**PLANNING APPLICATION P08/1163**  
**14-16 VIEW POINT ROAD, MCCRAE**

### **REVIEW OF SCHEMATIC FOOTING DESIGN**

**Proposed Residential Dwelling: 14-16 View Point Road McCRAE VIC.**

We confirm receipt of schematic section (SK1) and plan (SK2) from Eckhaus Story and Partners Pty Ltd relating to the conceptual footing system for the proposed dwelling at the above site. Copies of the sketches are attached.

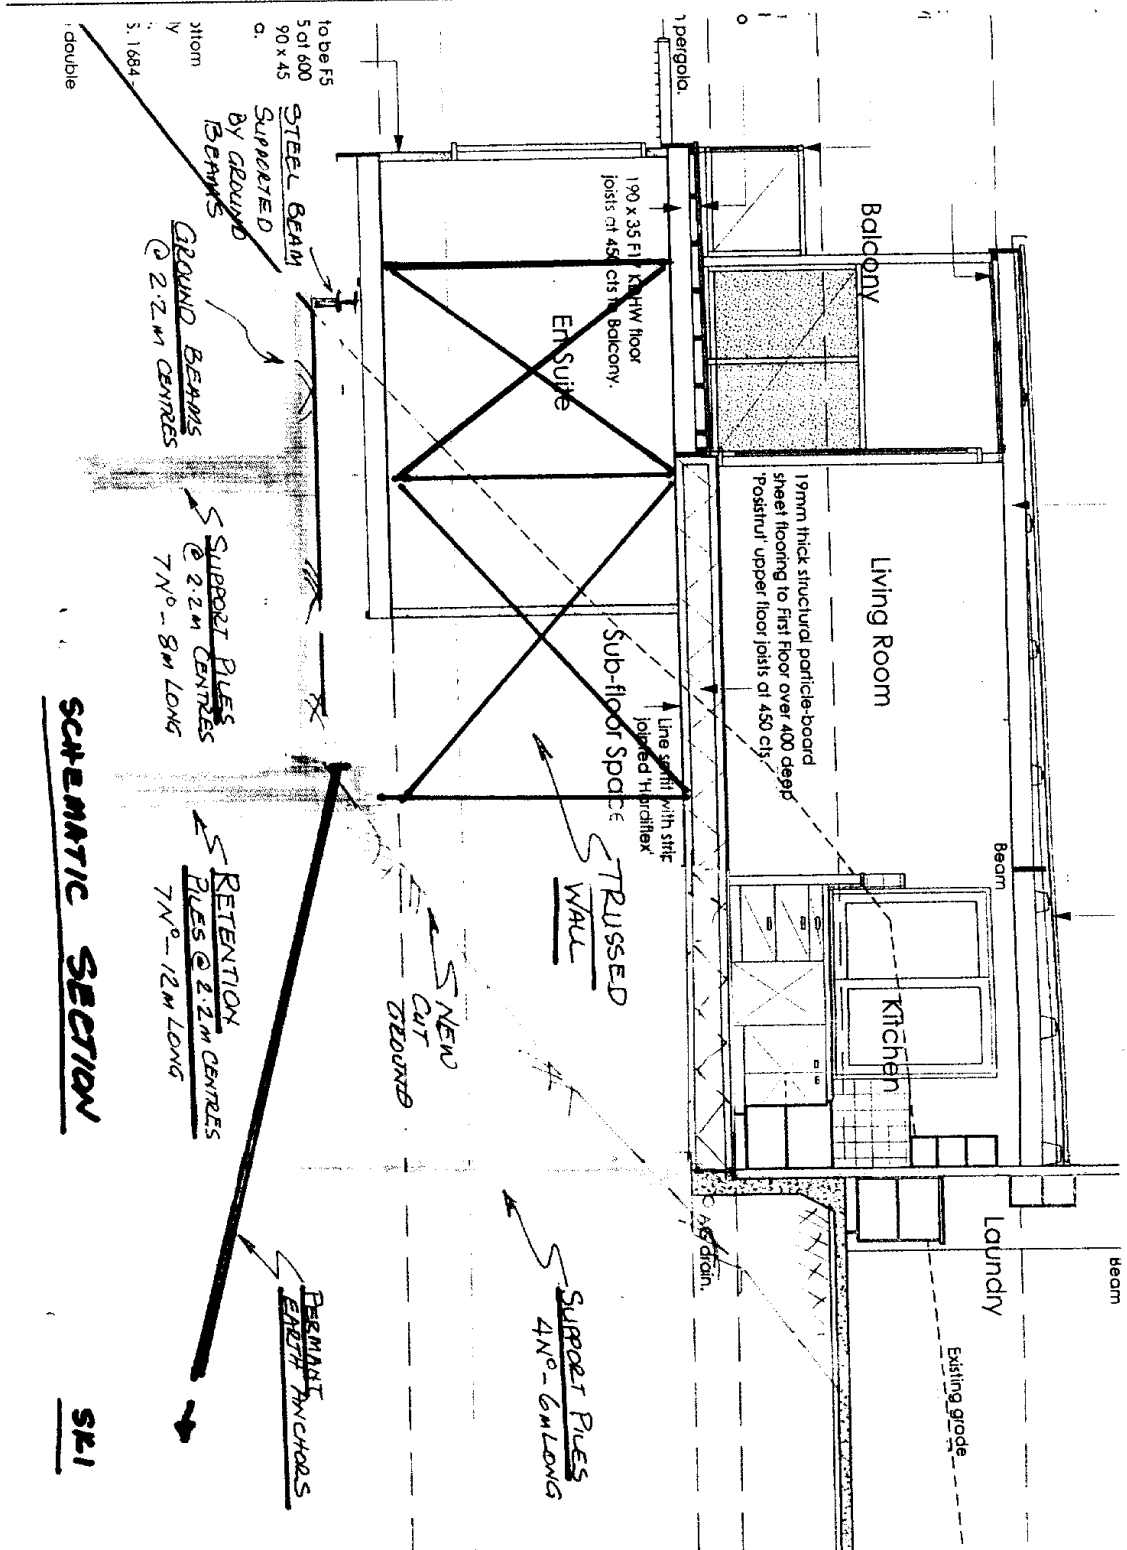
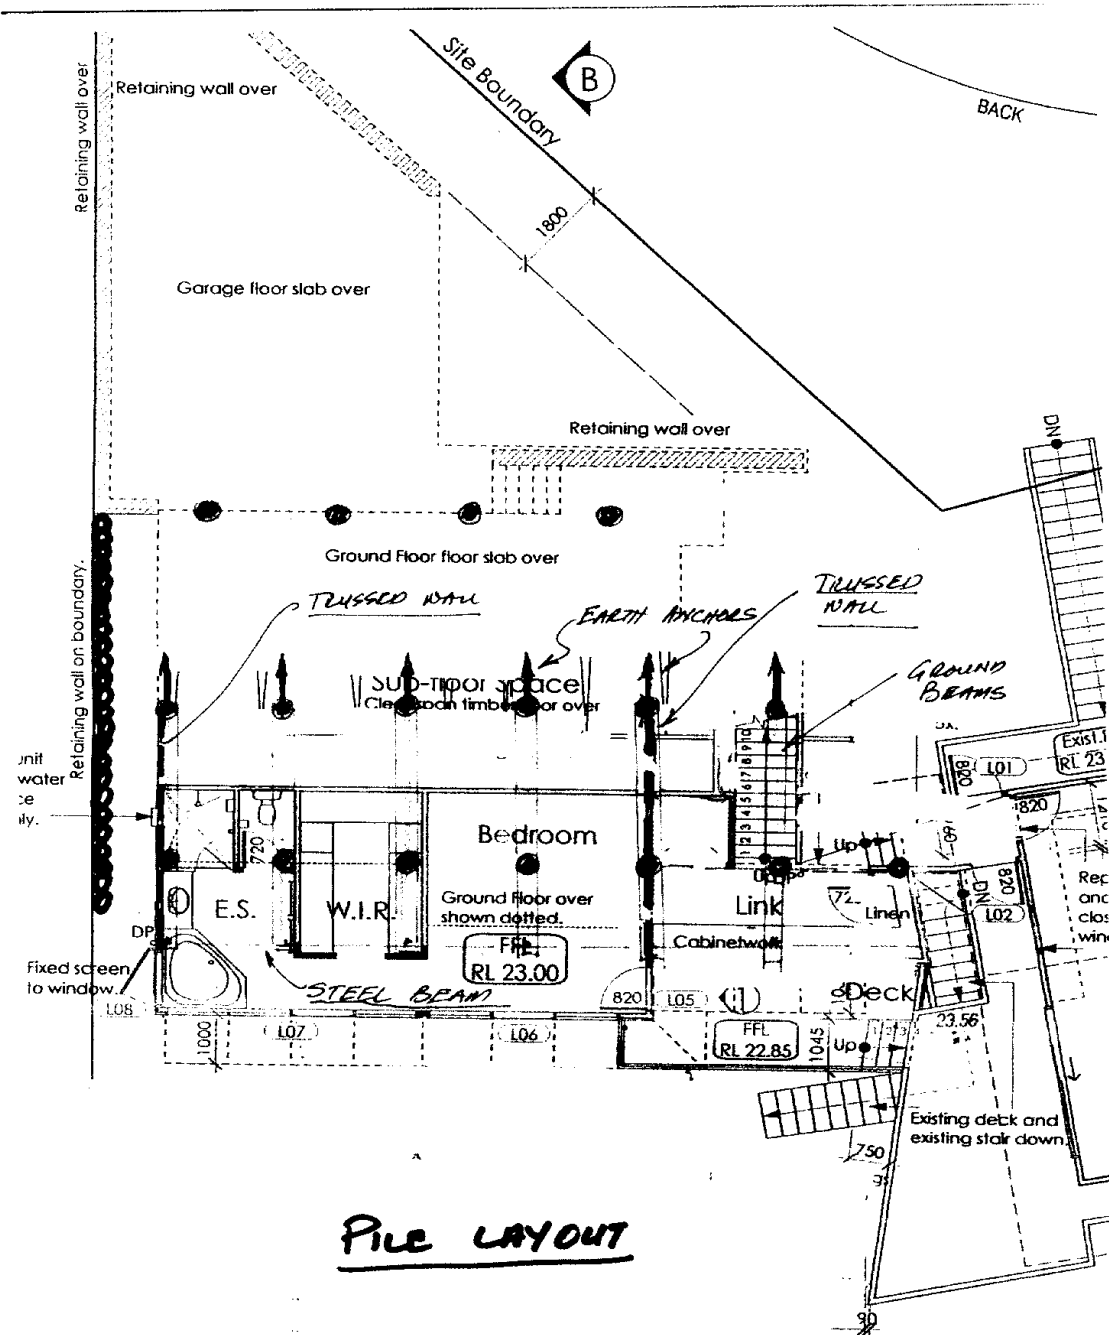
We understand the footing design will be further refined once the design of the proposed structure is progressed. However, in concept the proposed schematic footing system is consistent with the recommendations contained within our geotechnical report. On this basis the risk to property for the proposed dwelling is low and the risk to life for the occupants of the proposed dwelling is tolerable, based on a landslide risk assessment in accordance with The Australian Geomechanics Society 'Practice Note Guidelines for Landslide Risk Management', 2007.

The final design of the footing and retention systems for the proposed development must be approved by this office prior to issue of the building permit.
